Minutes of the 10th Meeting of the Expert Appraisal Committee for River Valley and Hydroelectric Projects held on 05.12.2017 at Teesta Meeting Hall, Indira Paryavaran Bhavan, Jor Bagh Road, New Delhi-3.

Item No. 10.1 Shivasamudram Run- Of -the- River Power Project (2x100 MW) Phase-I in Chamarajnagar district, Karnataka by M/s Karnataka Power Co. Ltd- For Fresh ToR – reg.

Item No. 10.3 Pancheswar Multipurpose (5,600 MW) project in Uttarakhand by Pancheswar Development Authority – Discussion of the Site Visit Report and reconsideration of Environmental Clearance

Item No. 10.4 Kaleswaram Project in Karimnagar District of Telengana by Irrigation and CAD Department, Govt. of Telengana – For Fresh EC

3- pH level monitoring of Kopili river water at the site

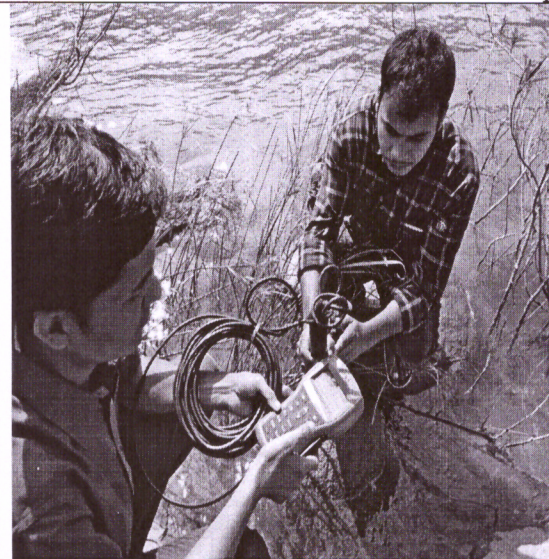
The Sub-committee also suggested that pH value may be monitored from the TRT location of the Kopili HEP to FRL location of the existing Lower Kopili HEP on a long term basis to understand the changing pattern of pH and drawing logical information thereof so that viability of proposed project can be further ensured on long run basis.

3. The Sub-committee also suggested that pH value may be monitored from the TRT location of the Kopili HEP to FRL location of the existing Lower Kopili HEP on a long term basis to understand the changing pattern of pH and drawing logical information thereof so that viability of proposed project can be further ensured on long run basis.

2- Drift site of Indian Portion visiting the Sub-committee

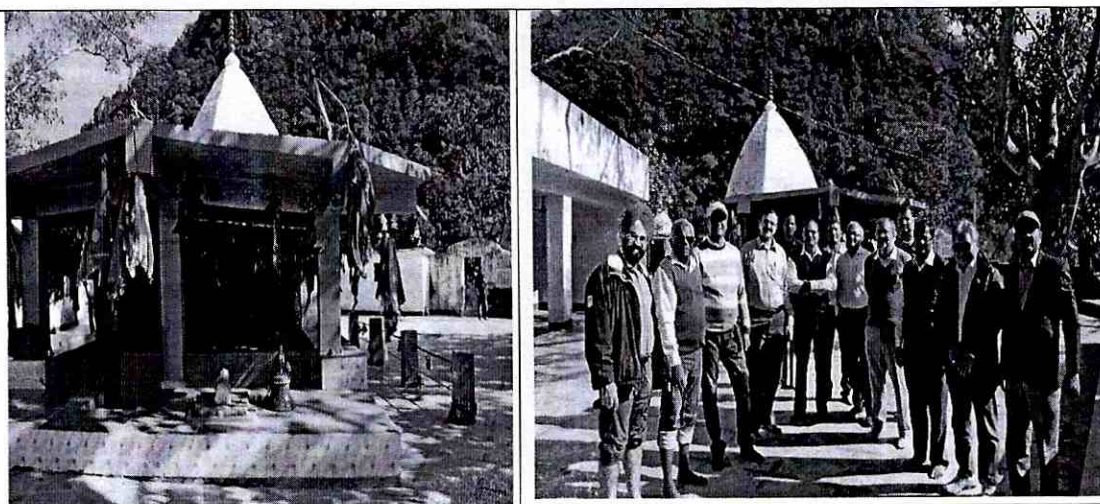
4. Drift site falling in India side was visited. It is suggested that appropriate plan be prepared for better utilization of the excavated drift, after the commissioning of the project.

3-Pancheswar Temple, to be shifted

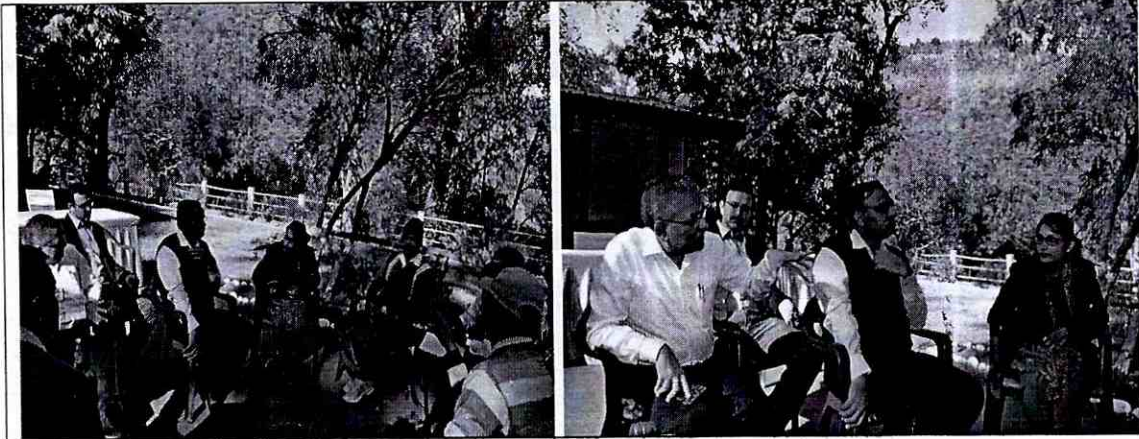
8. *There are three temples, namely Pancheswar, Taleswar and Pandeswar, which are to be shifted for which Rs. 20 crore has been earmarked. Before relocating the temples, concern from the villagers be addressed .*
